## STAFF REPORT

### Community Planning and Preservation Commission Certificate of Appropriateness Request

<b>Case No.:</b>	<b>22-9020052</b>
Address:	3328 7 <sup>th</sup> Ave N
Legal Description:	KENWOOD SUB ADD BLK 21, LOT 4
Parcel ID No.:	14-31-16-46350-021-0040
Date of Construction:	1979-1980
Local Landmark:	Kenwood Section – Northwest Kenwood Local Historic District (18-90300008) [Non-Contributing Property]
Owner:	Kim, Dae-Kun Kim, Lan

Request: Review of a Certificate of Appropriateness for an addition to 3328 7<sup>th</sup> Ave N, a non-contributing building within a local historic district

Figure 3: Proposed side (east and west) elevations

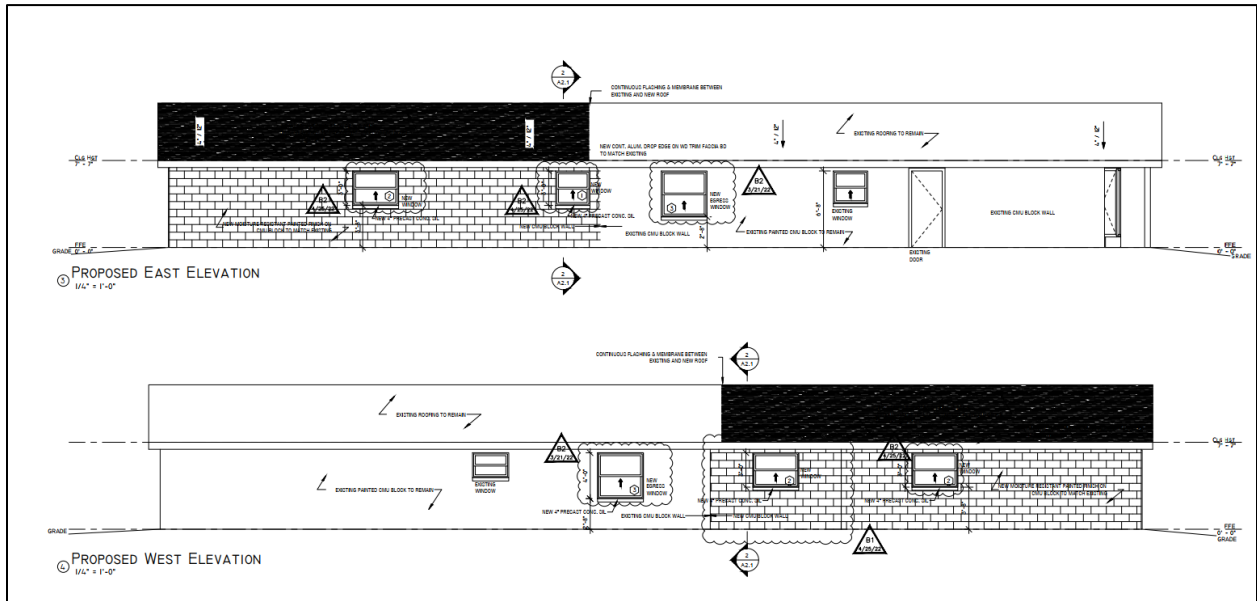
The property owner has added a recessed porch to the west elevation at the "seam" between the original home and the addition to create a visual break, evidence of the addition to the future viewer, and break down the massing of the building following input from City historic preservation staff.

The applicant has added a porch to the west side of the proposed addition to decrease the overall bulk of the building and reference the articulation

between residence and garage space that is typical to contributing properties in the subject district.

Figure 4: Proposed rear (south) elevation

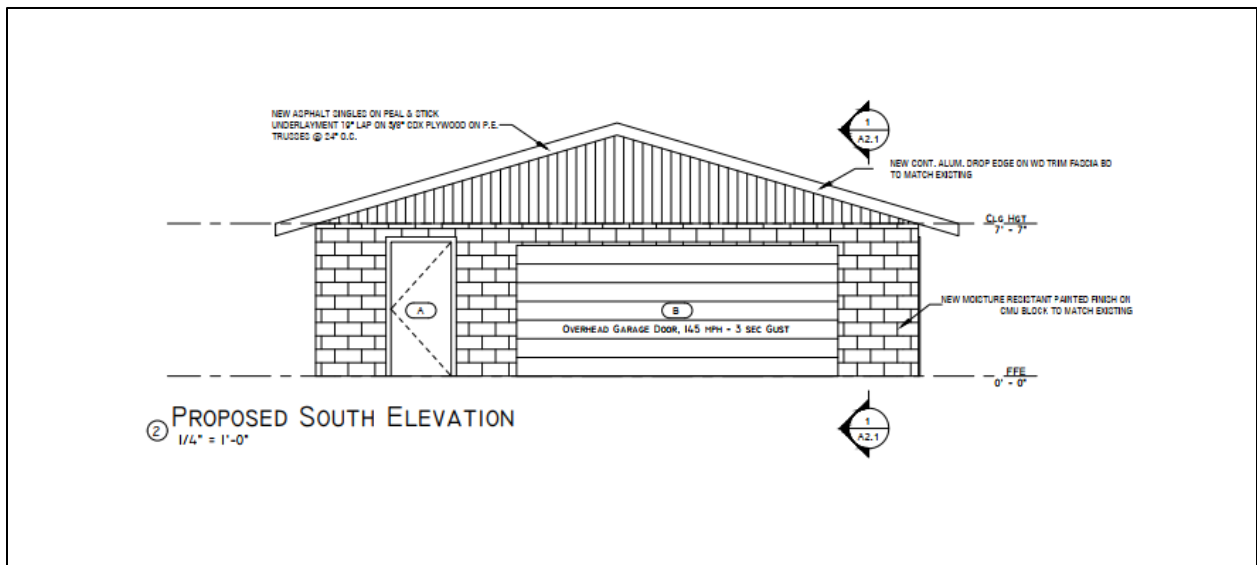
**Consistent** The proposed addition will be placed behind the existing residence and with a consistent gable peak to that of the existing roof form.

**Consistent**        The proposed roof will add to the rear-facing gable.

**Historical Board Review**

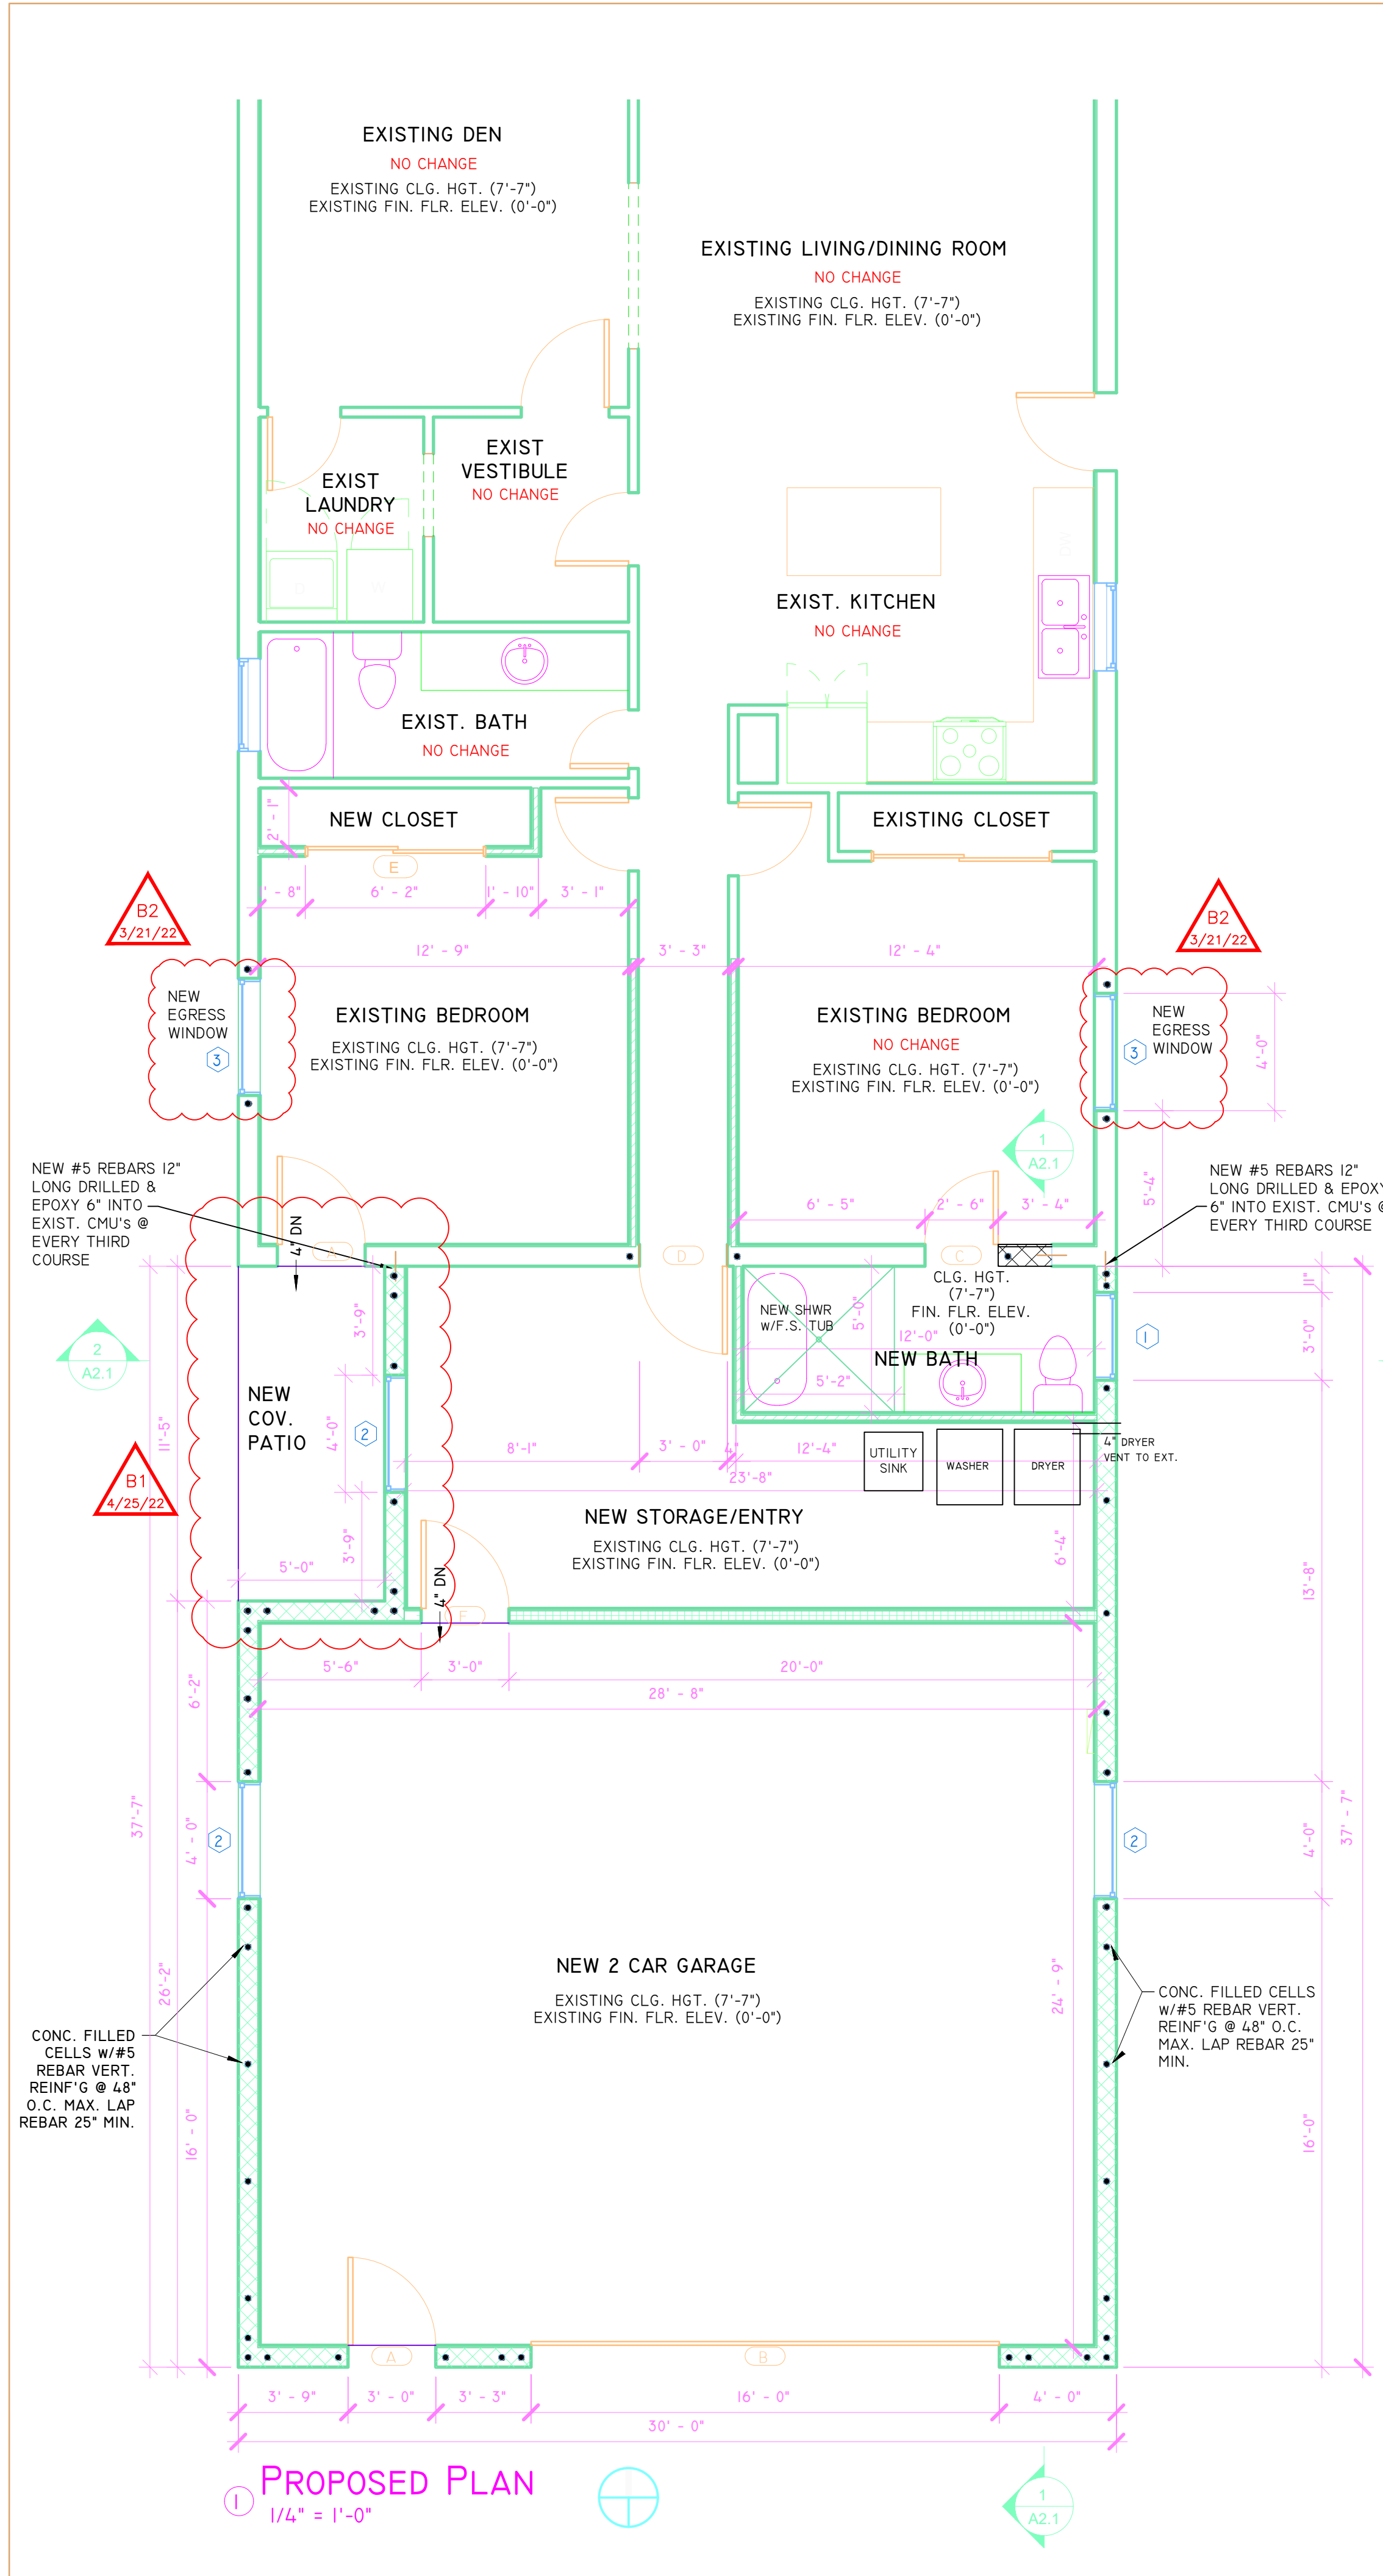
1. West side covered patio add to floor plans and elevations as shown on sheets 00, A1.0, A1.1, & A2.0. Revision B1.
2. New windows revised to match existing window style as shown on sheets A1.0 & A2.0, revision B2.
